SUBJECT: LONG TERM SEISMIC CRITERIA AND ANALYSIS METHODS
SAN ONOFRE NUCLEAR GENERATING STATION, UNIT 1

As you requested during a conference call on July 31, 1985, attached is a copy of a preliminary evaluation prepared by EG&G Idaho regarding the proposed strain-elastically calculated stress relationship. We request that you review this material in preparation for the meeting scheduled on August 14-15, 1985. If you have any questions regarding this material, please contact Thomas Cheng (301-492-8393).

Evaluation of SCE Proposed Stress-Strain Relationship

Figure 1. Function relationships: $K_e(S_n/35m) \leq K_s(\sigma_E/\sigma_y)$

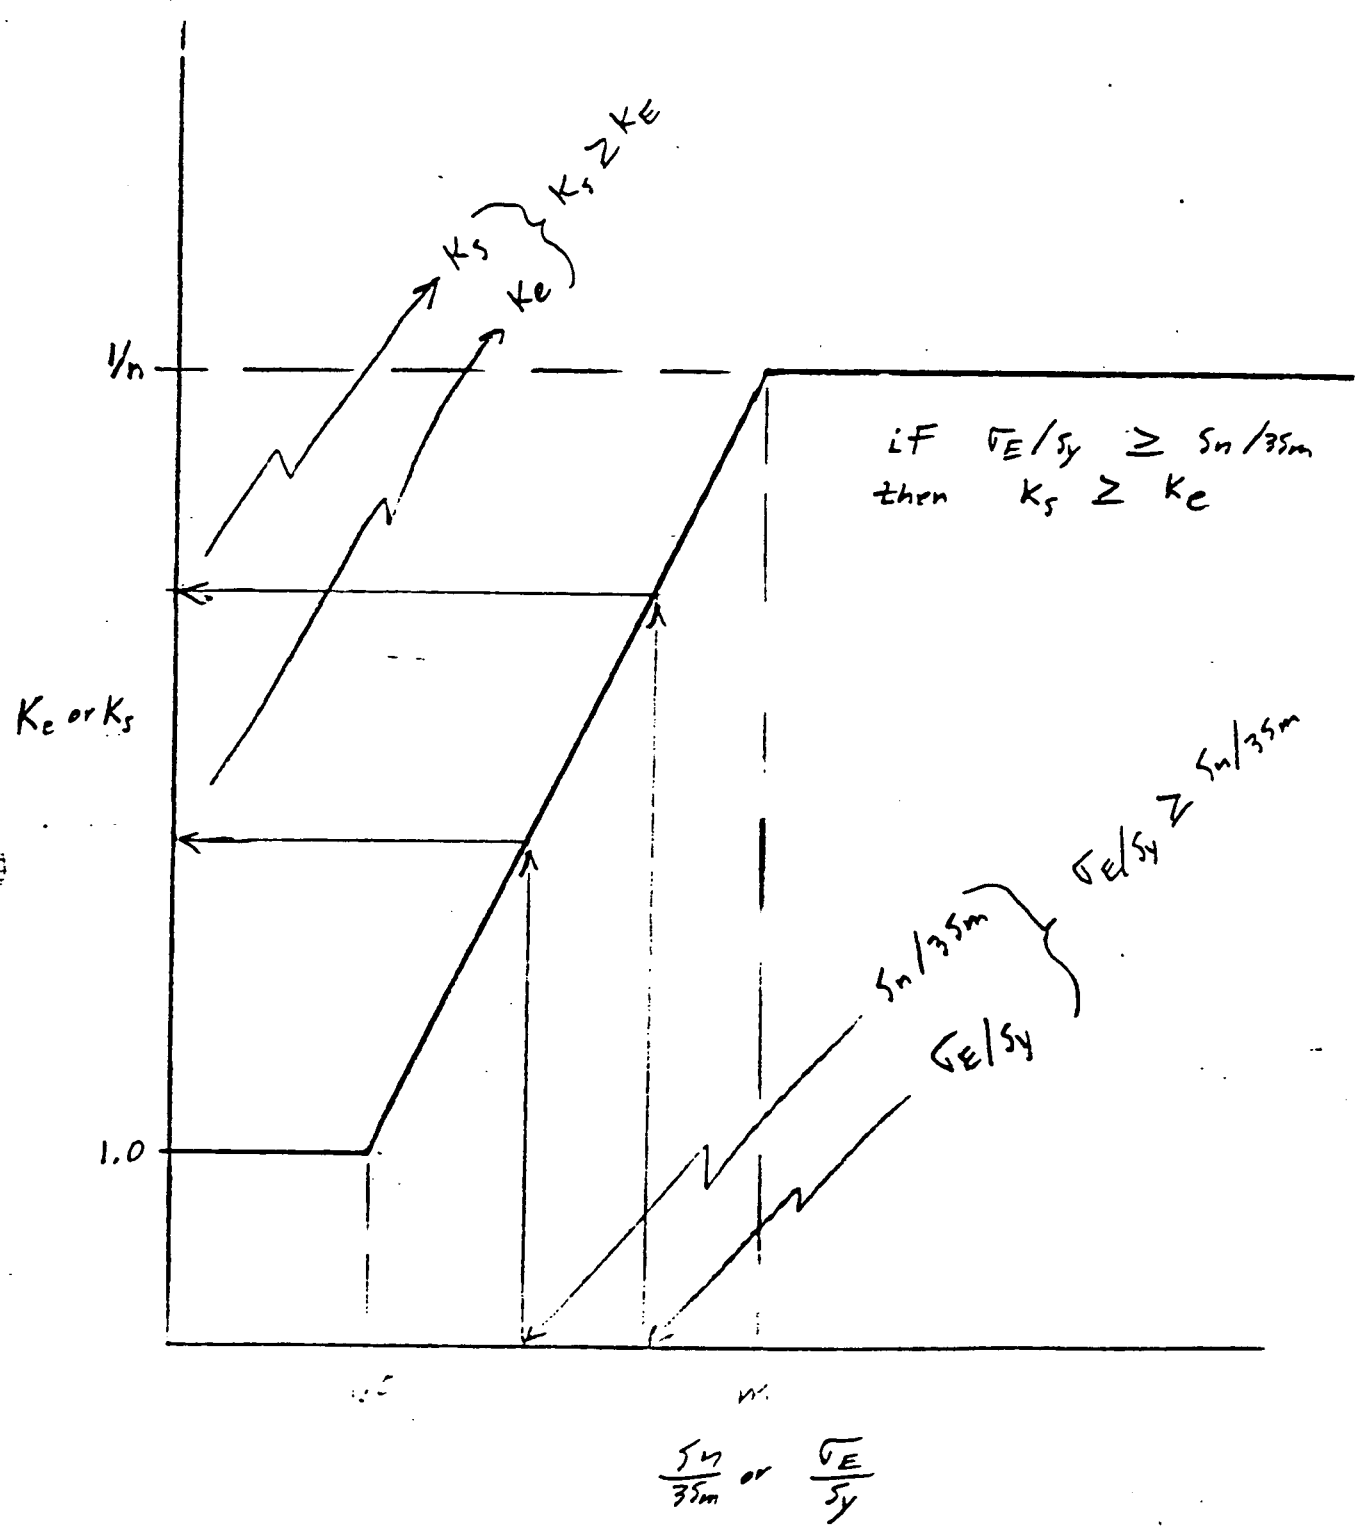
Since the K_e expression is acceptable code methodology, and since an investigation of its basis indicates that it is appropriate for use in a seismic calculation, the suitability of the K_s methodology will be based on a comparison to K_e . Given a specific component under a specific loading, both $S_m/3S_m$ and \sqrt{E}/S_y can be calculated. Based on the Figure given earlier, $K_s \geq K_e$ only if $\sqrt{E}/S_y \geq S_m/3S_m$.

Table 2 presents the range of S_n/\sqrt{E} calculated for the range of components and sizes which are likely to be found in SONGS 2. Based on table 2, a range of 2.0 to 5.8 has been chosen. Reducers have been neglected in the range because of the disparity in maximum values. The very large ratio for reducers reflects the large allowable variation in geometry, and may not represent the range of reducer geometries in the plant. Based on the chosen range of the stress ratio, the ratio of independent variables $((S_n/\sqrt{E})/(3S_m/S_y))$ is 10.74 - 3.39. This shows the proposed methodology to be non-conservative. To correct the situation, the following

Perform the calculation as proposed, except use $(3.39\sqrt{E}/S_y)$ in calculating K_s . IF the component being analyzed is a reducer, use

$S_n/3S_m$ in calculating K_s . Since the 3.39 value is conservative for most components, the option of using $S_n/3S_m$ should also be allowed in all other cases.
